ADDENDUM No. 3

**AIP #3-23-0005-070-2016
Gate 3 Passenger Boarding Bridge & Holding Area**

at Bangor International Airport – Bangor, ME

Date: _____ **April 28, 2016** _____

HOT WATER HEATING COIL PIPING SCHEMATIC
NOT TO SCALE

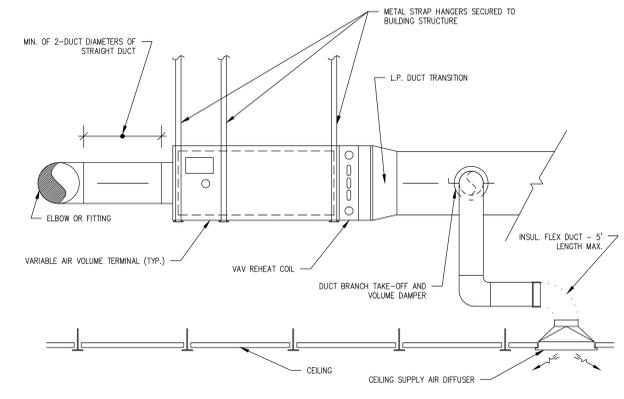
REMOVE and REPLACE Drawing No. M-007 *MECHANICAL DETAILS* with the revised drawing provided as an attachment to this addendum.

Changes to the drawing include revisions to the hot water heating coil piping schematic.

MECHANICAL CONTROLS

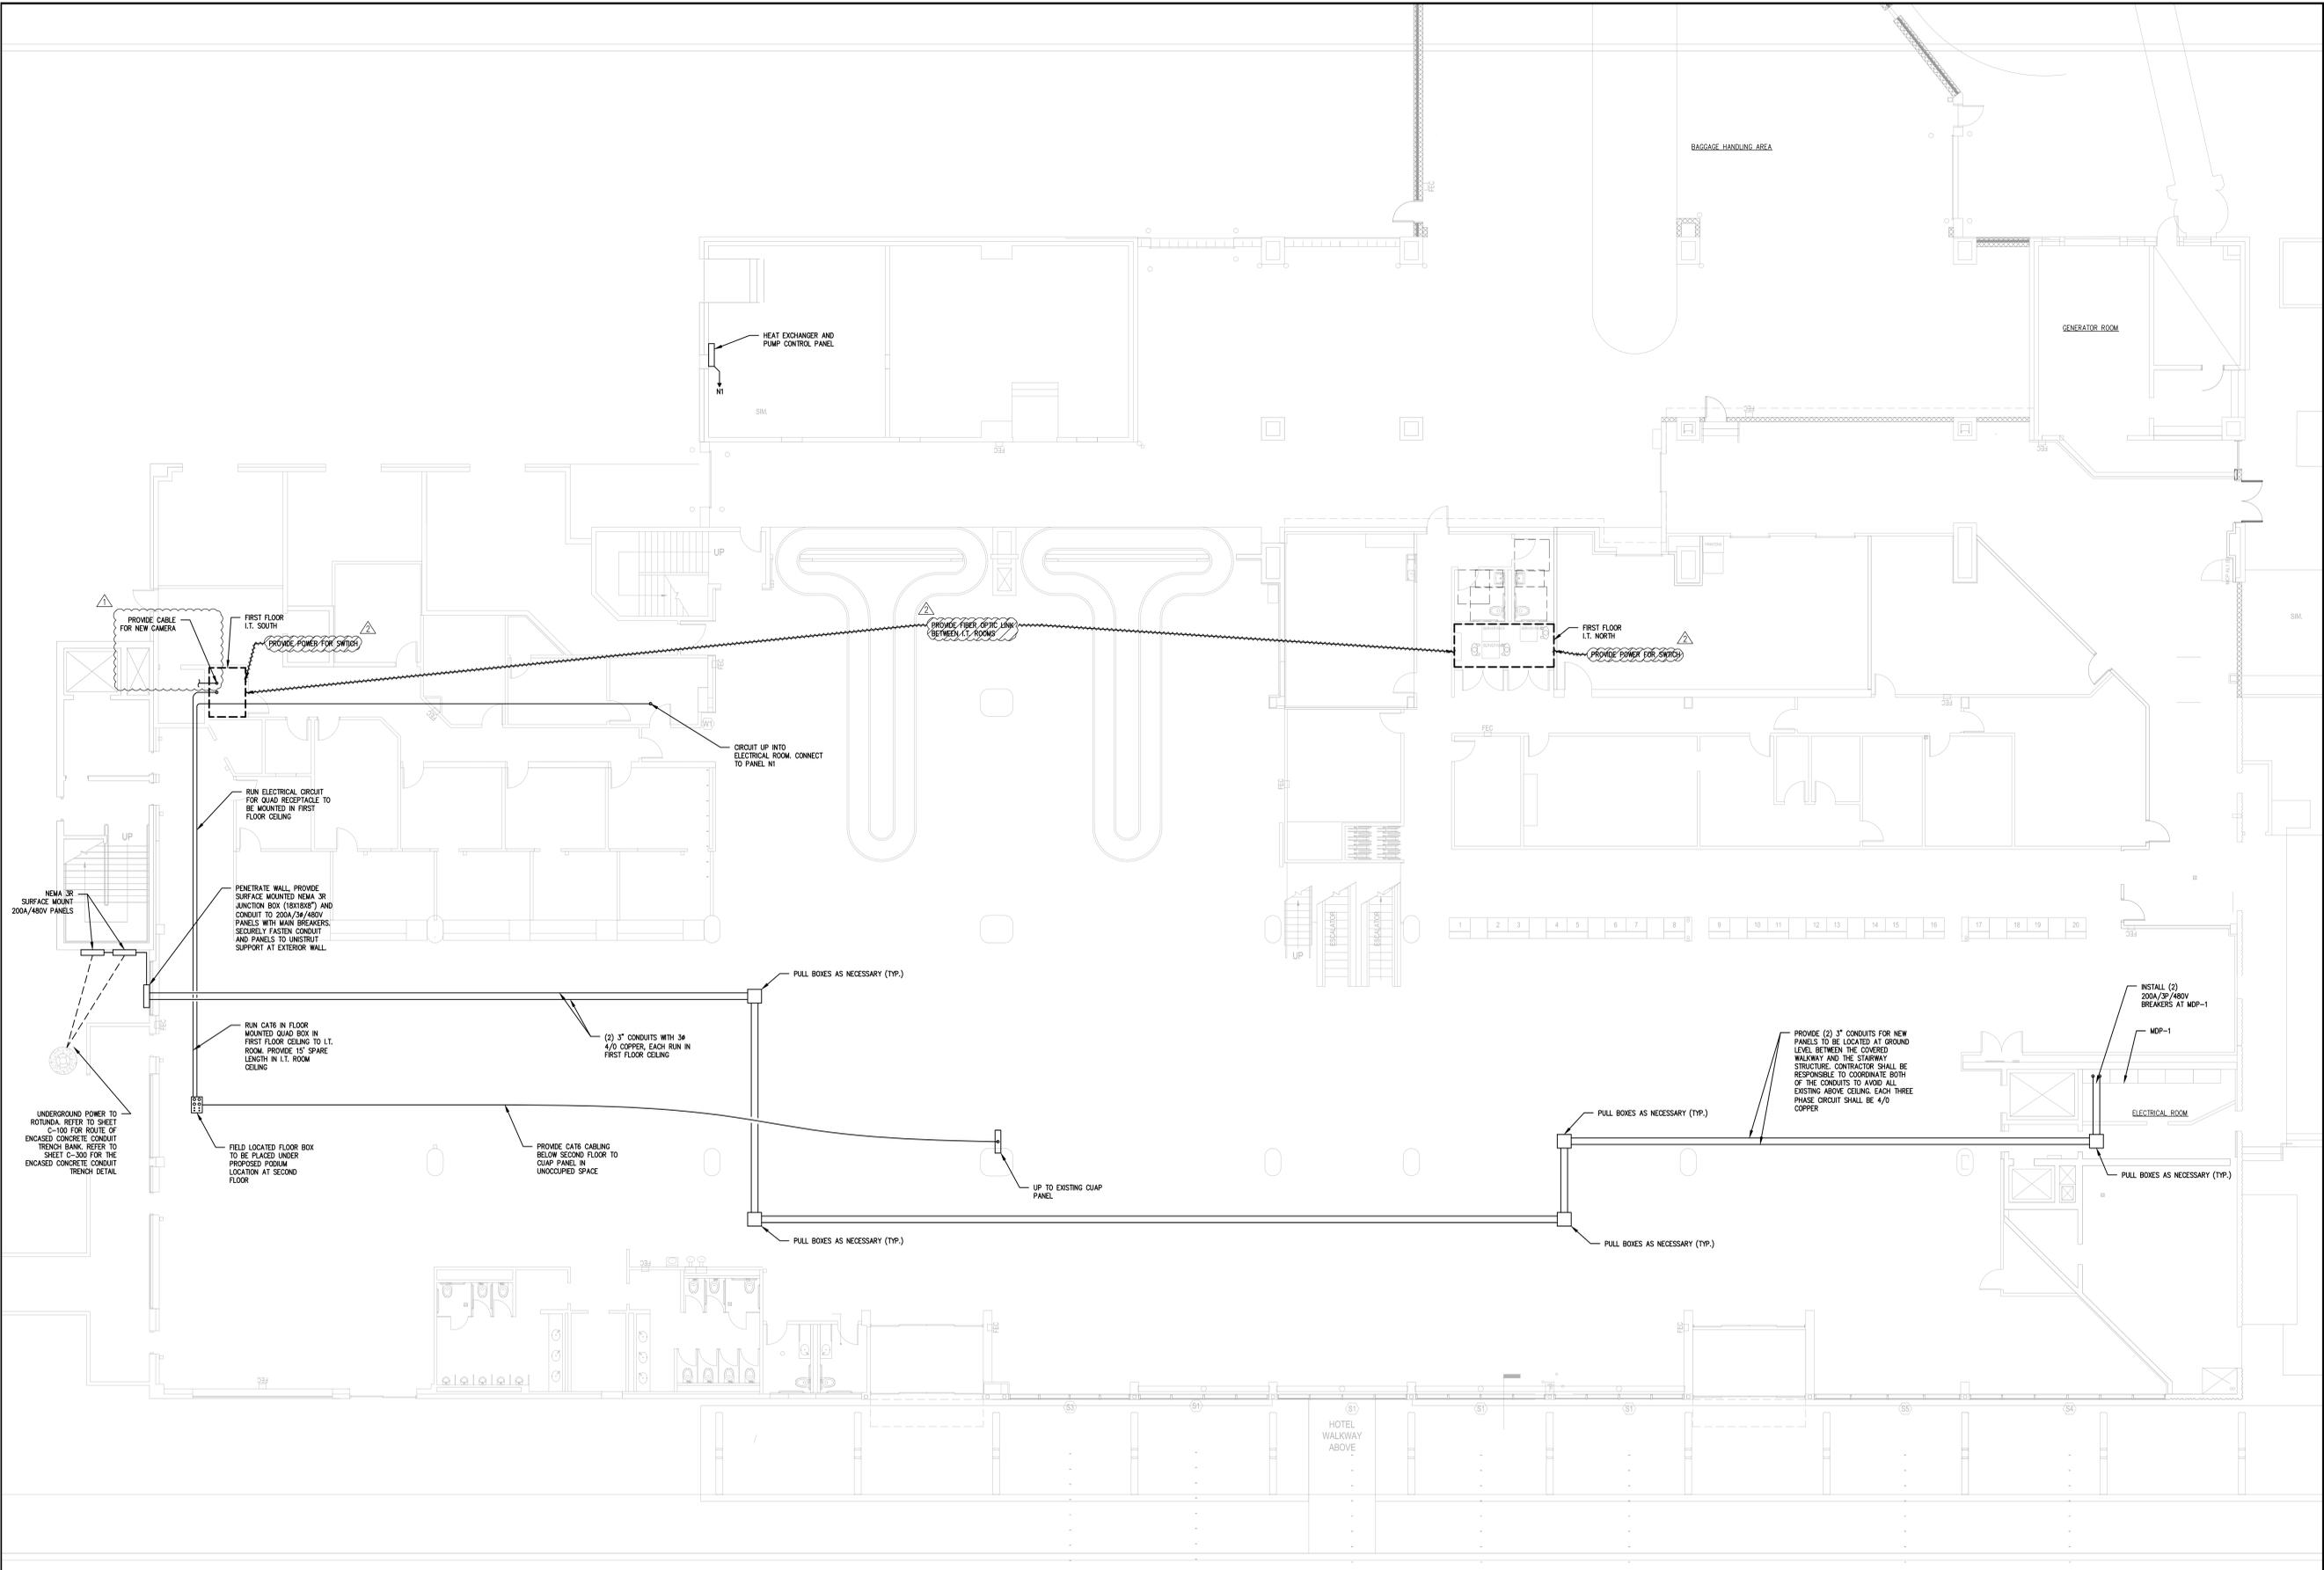
REMOVE and REPLACE Drawing No. M-008 *MECHANICAL CONTROLS* with the revised drawing provided as an attachment to this addendum.

Changes to the drawing include revisions to the controls on the new roof top unit.
